UNITED STATES PATENT AND TRADEMARK OFFICE

| APPLICATION NO. | FILING DATE | FIRST NAMED INVENTOR | ATTORNEY DOCKET NO. | CONFIRMATION NO. |
|---|-------------|----------------------|---------------------------|------------------|
| 10/707,416 | 12/12/2003 | Yu-Chi Lee | CPTP0001USA | 1415 |

| Office Action Summary | Application No. 10/707,416 | Applicant(s) LEE ET AL | |

DETAILED ACTION

FIG. 1

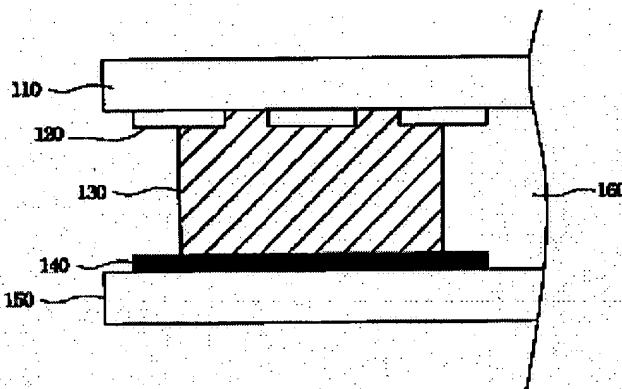
8. Lee discloses (page 1, paragraph 0010; page 2, paragraph's 0021-0024) and shows in Fig. 1, a one drop fill (ODF) liquid crystal display (LCD) panel comprising::

- a first substrate (150) comprising:

- a pixel array region (not shown) positioned on a central part of the first substrate (150);
- a sealant region positioned on a bordering part of the first substrate and surrounding the pixel region; and
- a metal light-shielding pattern (140) positioned on a surface of the sealant region;

- a second substrate (110);
- a sealant pattern (130) positioned between the first substrate and the second substrate and corresponding to the sealant region for combining the first substrate with the second substrate; and
- a liquid crystal layer (160) positioned between the first substrate and the second substrate.

Accordingly, claims 1, 8-11 and 18-21 are anticipated.

As to claims 2 and 12, Lee also discloses that the sealant pattern (130) is UV type (page 2, paragraph 0022) (applicant's photocuring sealant).

FIG. 4

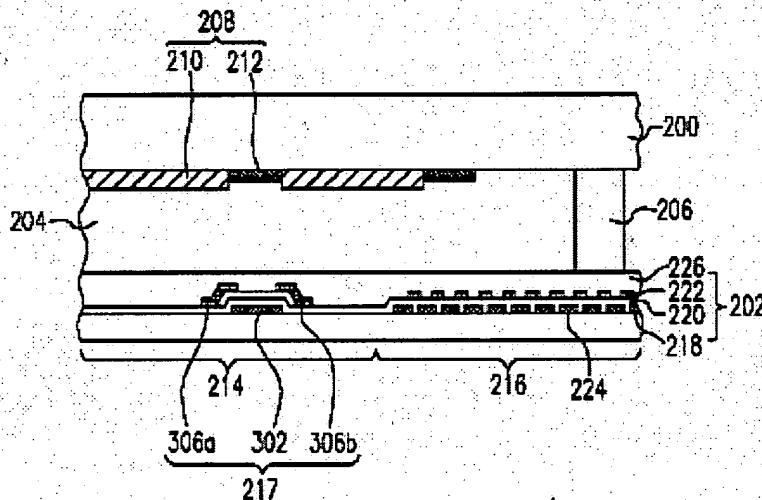
11. Chu discloses and shows in Fig. 4, a one drop fill (ODF) liquid crystal display (LCD) panel comprising:

- a first substrate (202) comprising:
- a pixel array region (214) positioned on a central part of the first substrate;

- a sealant region (216) positioned on a bordering part of the first substrate and surrounding the pixel region; and

- light-shielding patterns (222, 224) positioned on a surface of the sealant region (216)
- a second substrate (200);
- a sealant pattern (206) positioned between the first substrate and the second substrate and corresponding to the sealant region for combining the first substrate with the second substrate; and
- a liquid crystal layer (204) positioned between the first substrate and the second substrate.

Accordingly, claims 1, 8-11 and 18-21 are anticipated.

As to claims 2 and 12, Chu also discloses that the sealant pattern (206) is fabricated from an UV photosensitive material (page 3, paragraph 0036) (applicant's photocuring sealant).

As to claims 3, 4, 13, 14 and 17, Chu also discloses and shows in Fig. 4, that the light shielding pattern is for preventing light leakage through the sealant region (216), the light-shielding pattern comprising a first metal pattern (222), a second metal pattern (224), and a first insulation layer (220) positioned between the first metal pattern and the second metal pattern (Page 3, paragraph 0035) and that the pixel array region (214) further comprises a plurality of pixels arranged in arrays, each pixel including a thin film transistor (217).
